Rack space estimate for SPB expt. hutch

This update: 9.3.2012

Input: T.Haas, C.Youngman, A.Mancuso, A.Aquila, N.Coppola,
...

Conceptual floor plan for SASE 1 instruments

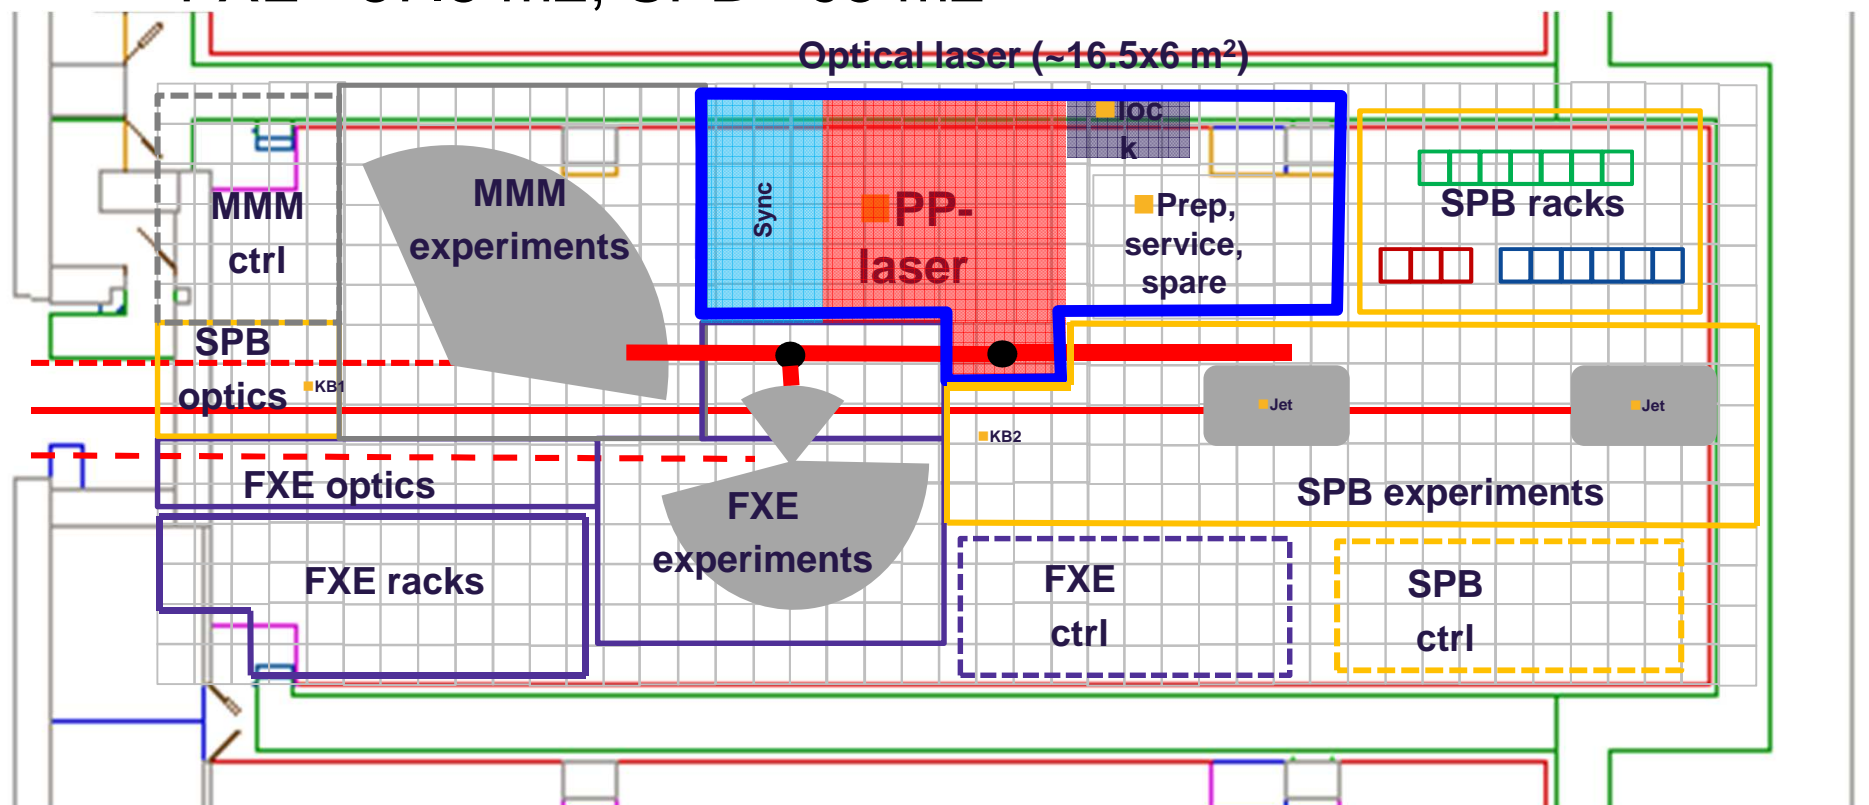
- Tobias and Niko: work in progress, MMM= 80-90 m², FXE= 87.5 m², SPB= 95 m²
